The AVR32DB28/32/48 devices you have received conform functionally to the current device data sheet (www.microchip.com/DS40002301), except for the anomalies described in this document. The errata described in this document will likely be addressed in future revisions of the AVR32DB28/32/48 devices.

3. Data Sheet Clarifications

Note the following typographic corrections and clarifications for the latest version of the device data sheet (www.microchip.com/DS40002301).

Figure 34-1. DAC Block Diagram

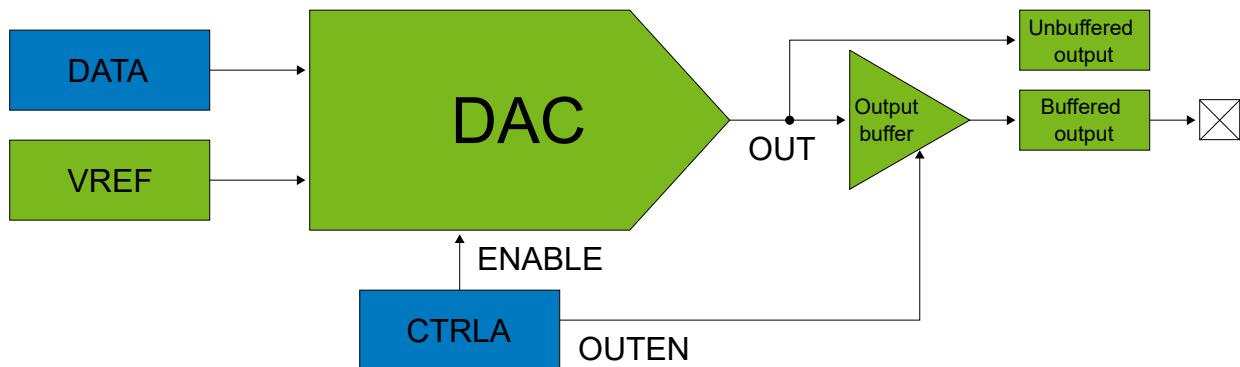
Clarifications of the block diagram and the DAC Output sub-section of the DAC peripheral has been made:

1. The block diagram is updated with clarifications to the output signal routing (buffered/unbuffered) and will replace the original block diagram.
2. Sections 34.3.2.3 (DAC as Source For Internal Peripherals) and 34.3.2.4 (DAC Output on Pin) are replaced by section 34.3.2.3 DAC Output.

34.3.2.3 DAC Output

The DAC can be used as an output to a pin and as an input to the peripherals in the table below.

34.3.2.3.1 Unbuffered Output as Source For Internal Peripherals

The unbuffered analog output of the DAC can be internally connected to other peripherals when the ENABLE bit in the Control A (DACn.CTRLA) register is written to '1'. When only the DAC unbuffered analog output is used, the Output Buffer Enable (OUTEN) bit in DACn.CTRLA can be '0', freeing the pin to be used by other peripherals.

34.3.2.3.2 Buffered Output

The buffered analog output of the DAC can be enabled by writing a '1' to the Output Buffer Enable (OUTEN) bit in the Control A (DACn.CTRLA) register. The pin used by the DAC must have the input disabled from the Port peripheral. Refer to the *Electrical Characteristics* section for information about the drive capabilities of the DAC output buffer.
